SERVICE INSTRUCTION

Introduction of a new clamp part no. 638140 for ROTAX 912 i Series

ATA System: 76-00-00 Engine control

Fig. 1

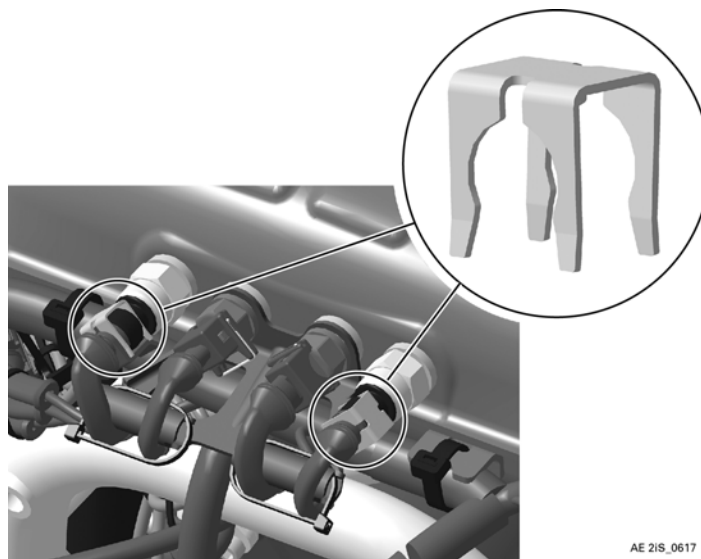
In the course of continuous development an additional clamp part no. 638140 has been introduced, which improves the connection and tight fit of the MAP sensors.

Step	Procedure
1	Check connector of MAP sensors for tight fit. NOTE: Make sure the connector latch shows vertically to the bottom.
2	Install the clamp as shown in figure 1. Check for tight fit and correct position of the clamp on sensor and connector. NOTE: To remove the clamp use a proper pair of pliers.
